Subject: Engineering, Procurement and Construction (EPC) Contract for Renovation and Modernization of Existing Navigational Lock at Farakka, West Bengal.

Reference: IN-IWAI-350002-CW-RFB-2

Amendment-5

Amendment triggered due to pre-bid responses:

CONSULTANT	NAME	SIGN	DATE
PKS FLOODKON JV	DRN		
	CHD		
	APD		
TITLE	JOB. NO.	DRG. NO.	
GENERAL ARRANGEMENT DRAWING OF EXISTING NAVIGATION LOCK, FARAKKA		ENL003

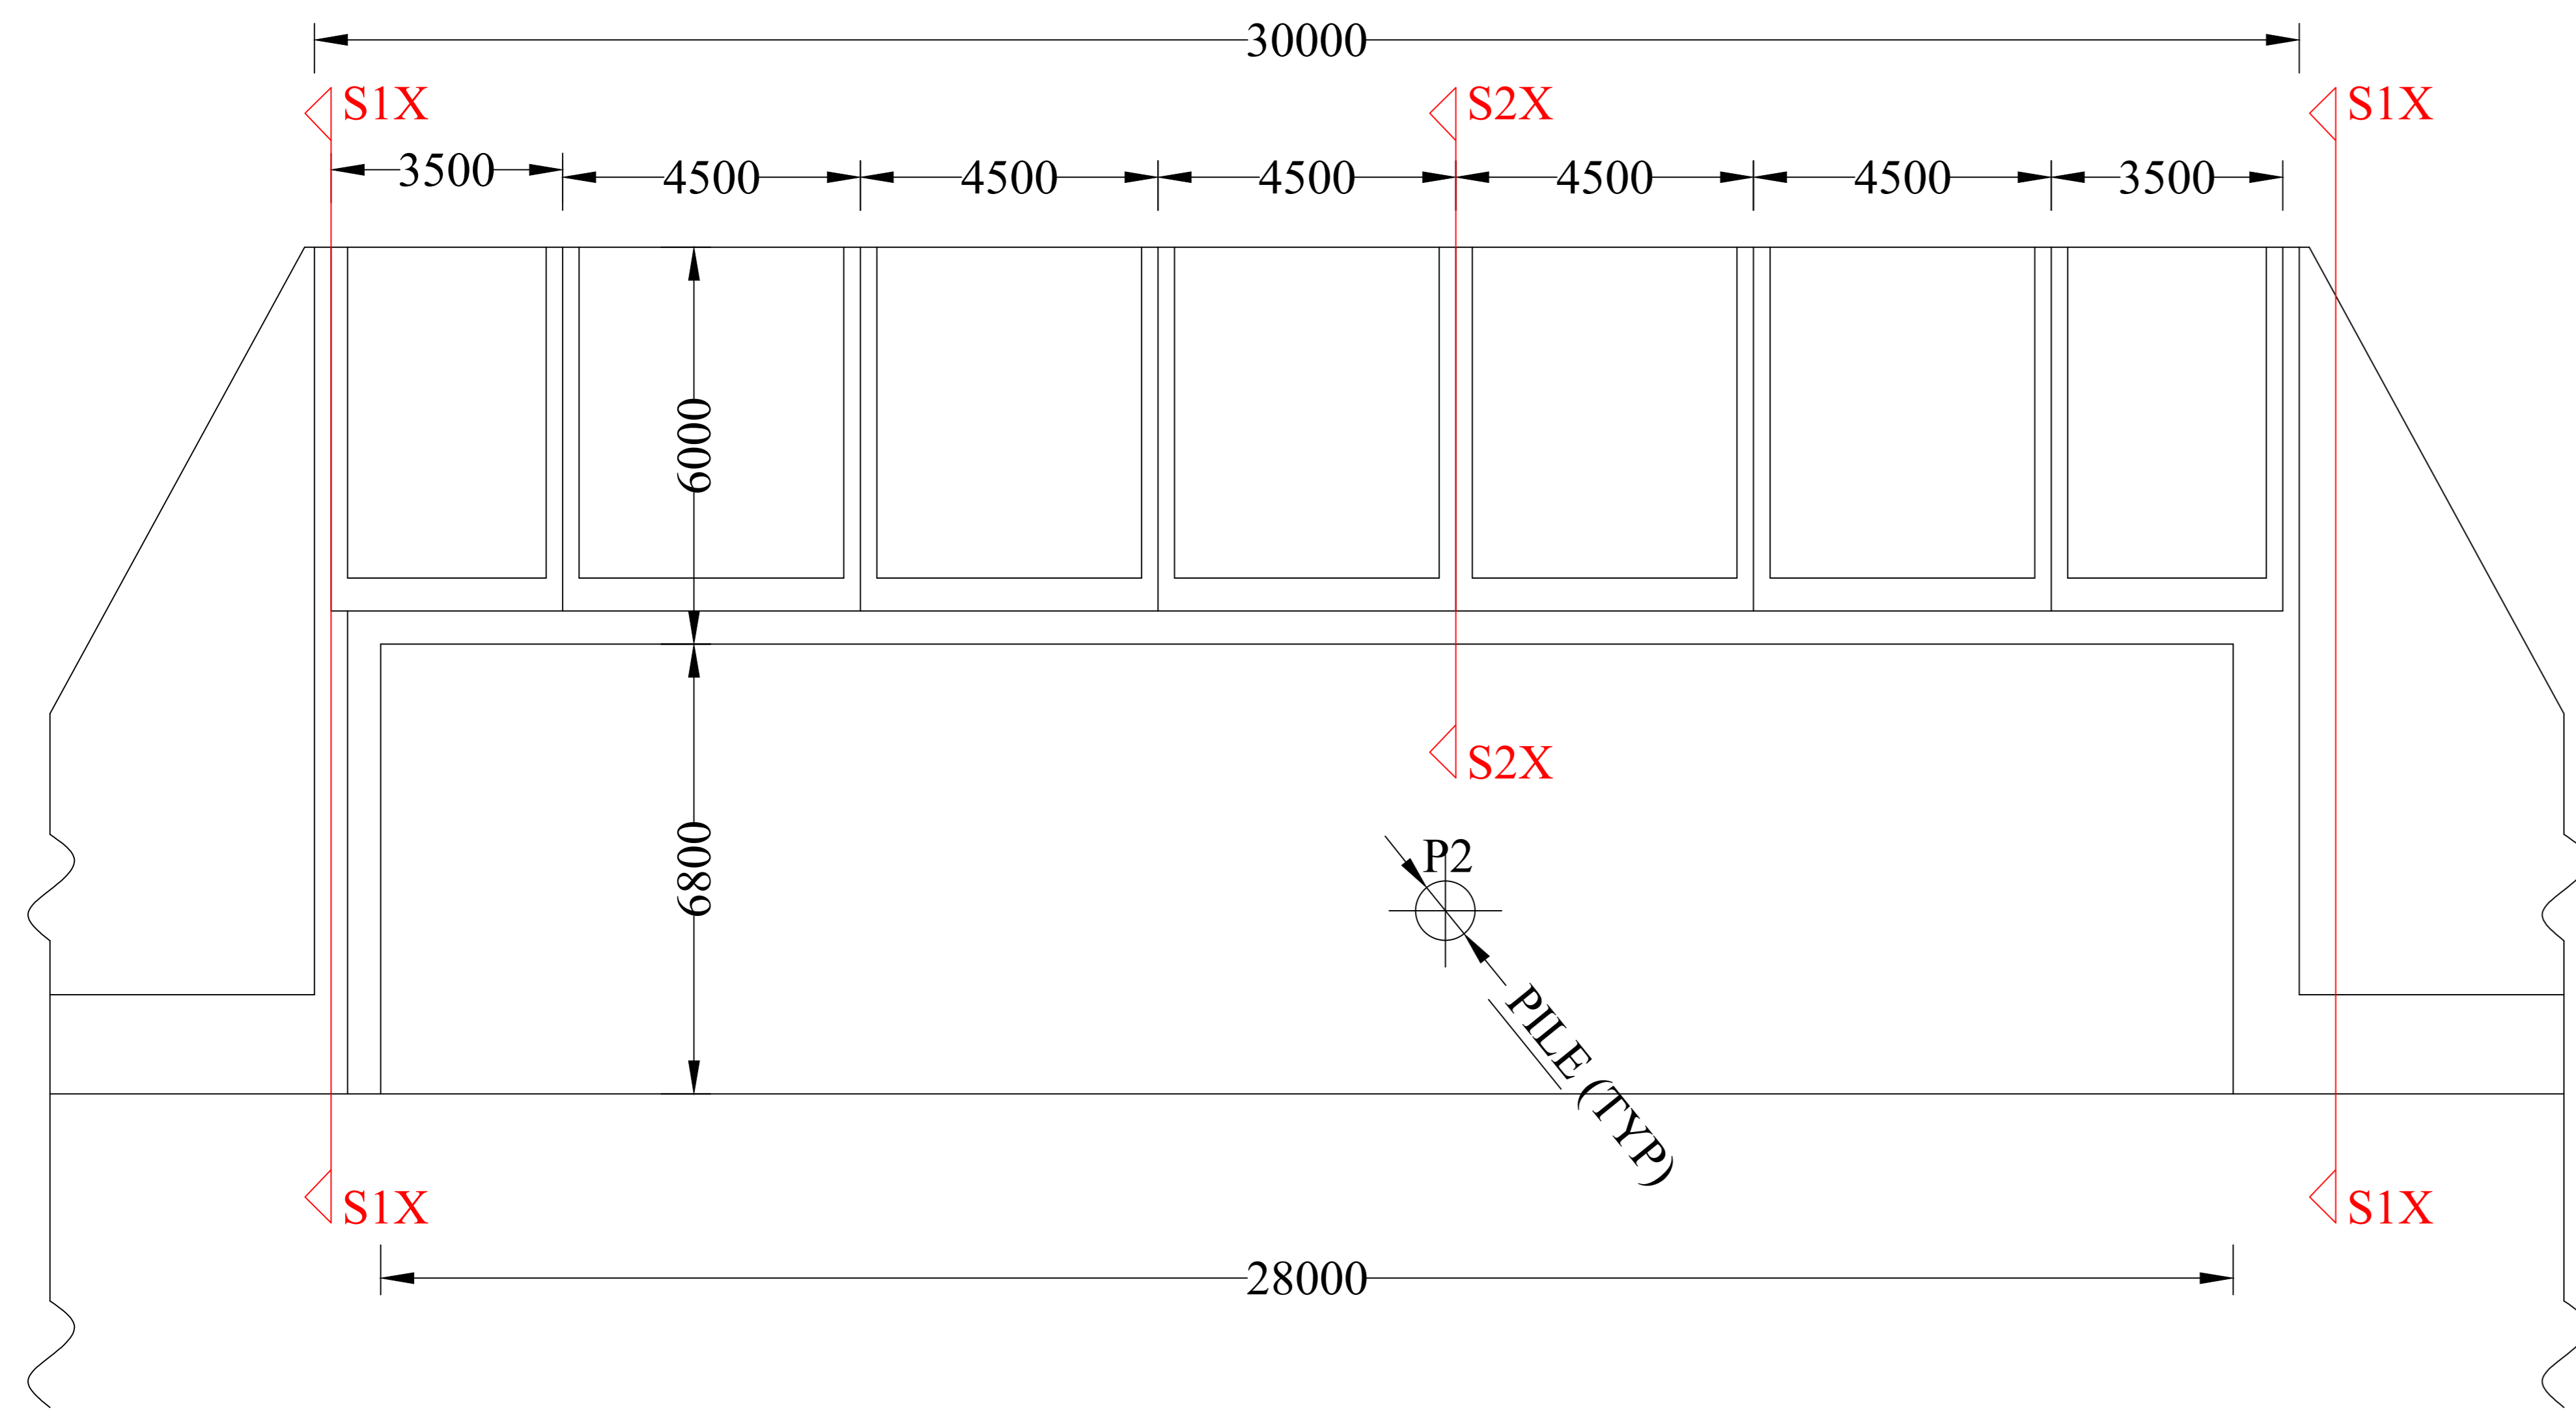
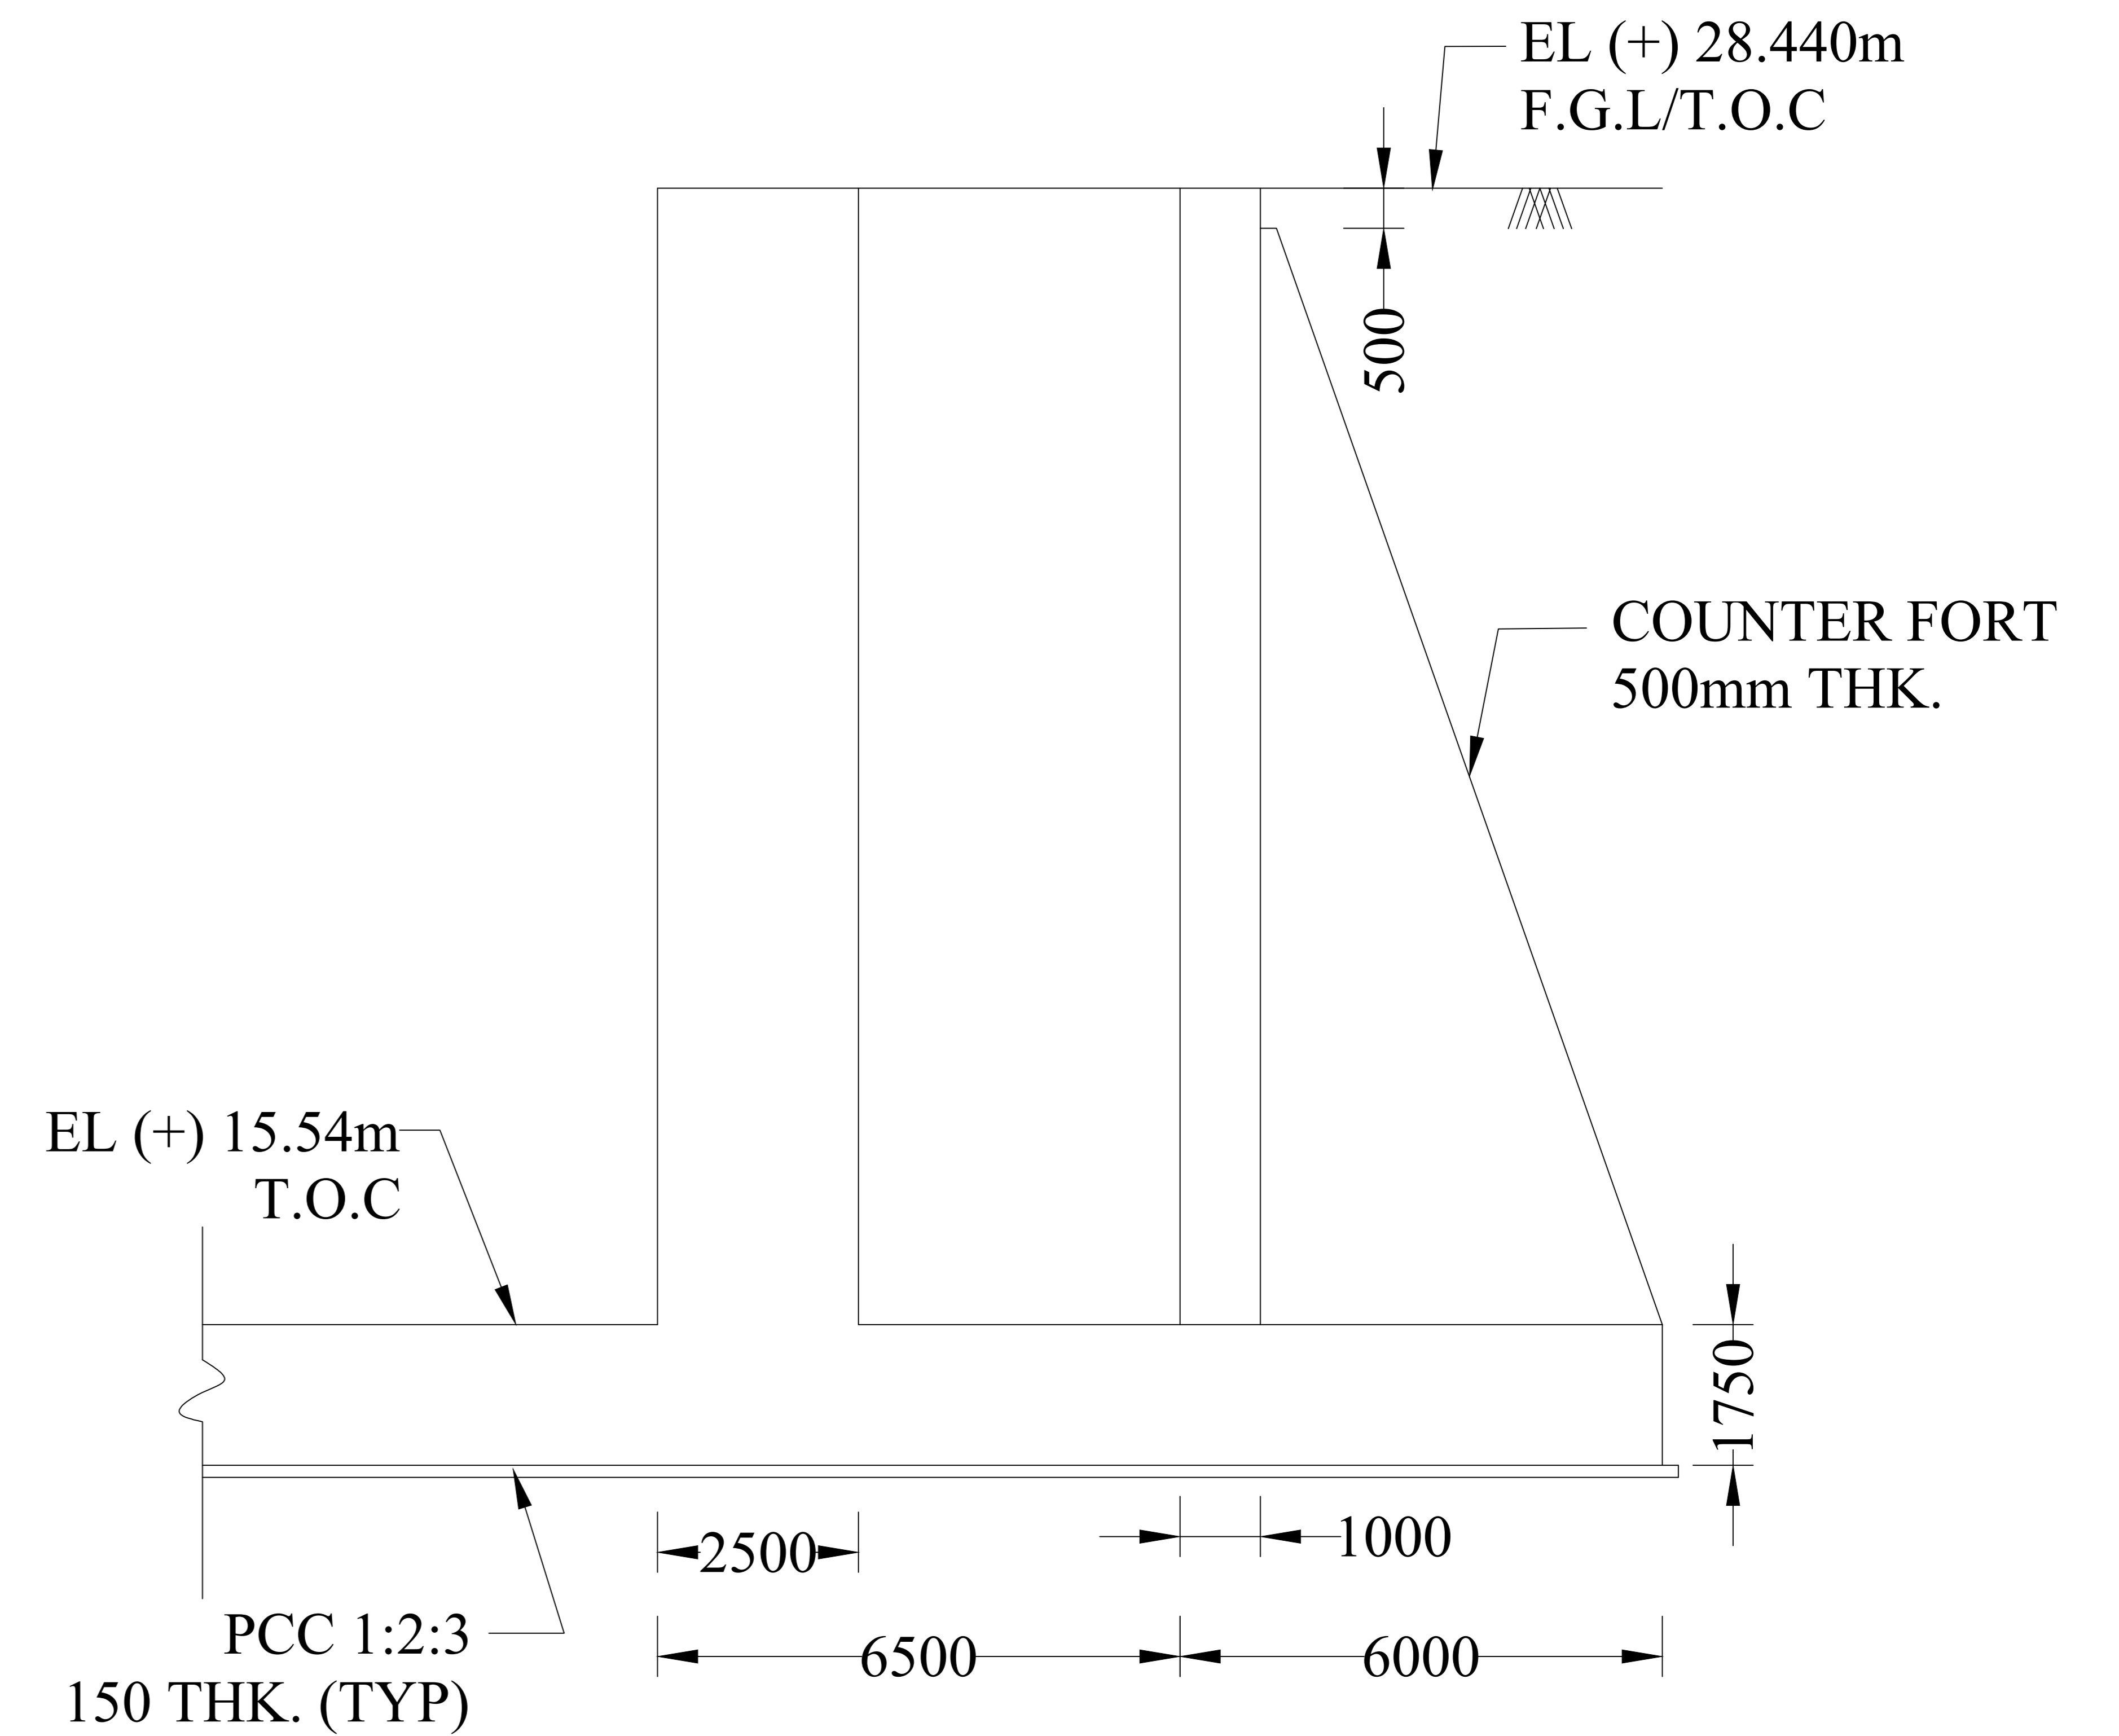
30	Drawing No. ENL-003, Vol-2, BoQ item no 7 & clause no 2.5.3 of Vol-3 at page no 12	<p>Control Rooms</p> <p>Engineering, Procurement and Construction of Control Room Building including local control rooms (2 Nos)</p> <p>Control Room Building Renovation and modernization of existing main control room building along with local control rooms (2 Nos) including mobilization & de-mobilization as per approved designs, drawings and specifications including testing, inspection and defect rectifications, complete in all respects.</p>	<p>BoQ item no 7 & clause no 2.5.3 of Vol-3 at page no 12 may be read as:</p> <p>Engineering, Procurement and Construction of Control Room Building including local control rooms (4 Nos)</p> <p>Control Room Building Renovation and modernization of existing main control room building along with local control rooms (4 Nos) including mobilization & de-mobilization as per approved designs, drawings and specifications including testing, inspection and defect rectifications, complete in all respects.</p>
